DETAILS TO MEET CONDITIONS
F/2001/3329

PROPOSED ADDITIONAL CAR PARKING IN ACCORDANCE WITH PLANNING APPROVAL F/2001/3329
NEW MILL RESTAURANT.

scale	1:200	drg no	629/1 A
date	Mar 03

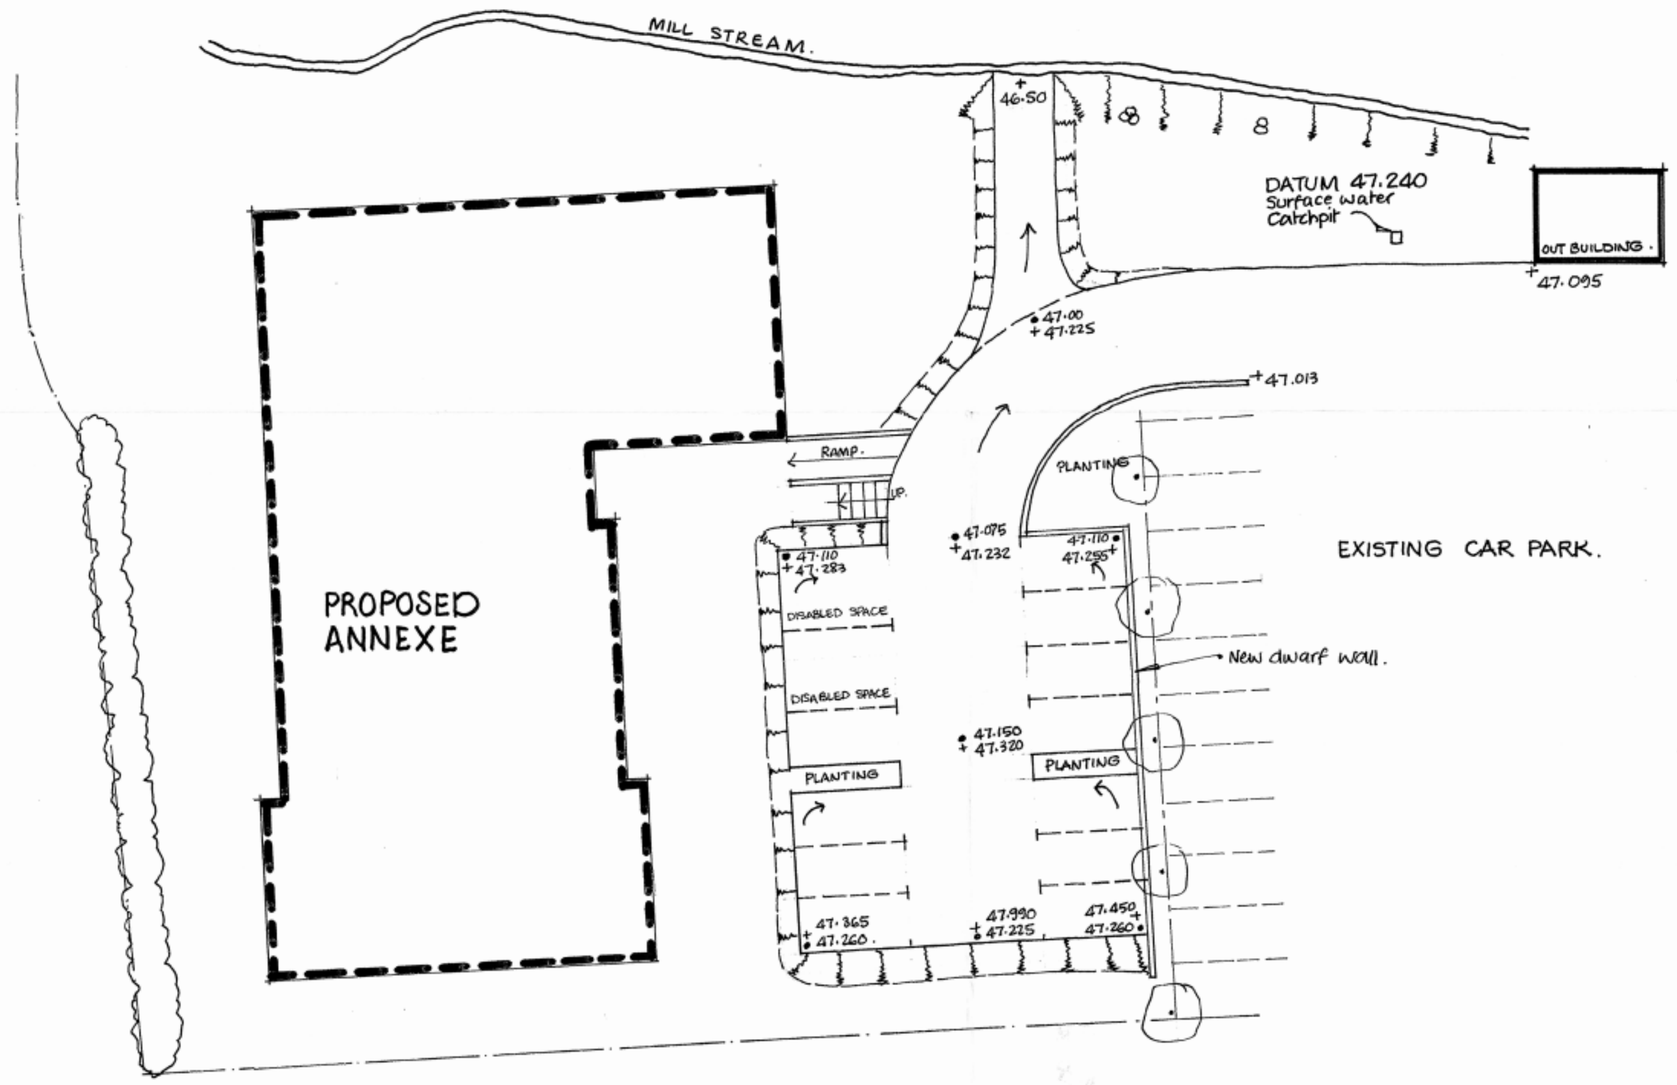
rev A. July 05. spec. for car park amended to coincide with drg no 11 as part of planning approval.

Remove top soil and lay min. 150 mm crushed concrete or rock scalpings. Base to be well consolidated and finished with washed gravel.

Kerbs to be 100 x 200 x 300 long countryside kerbs. on concrete bed + backing.

car park area must drain back toward mill stream
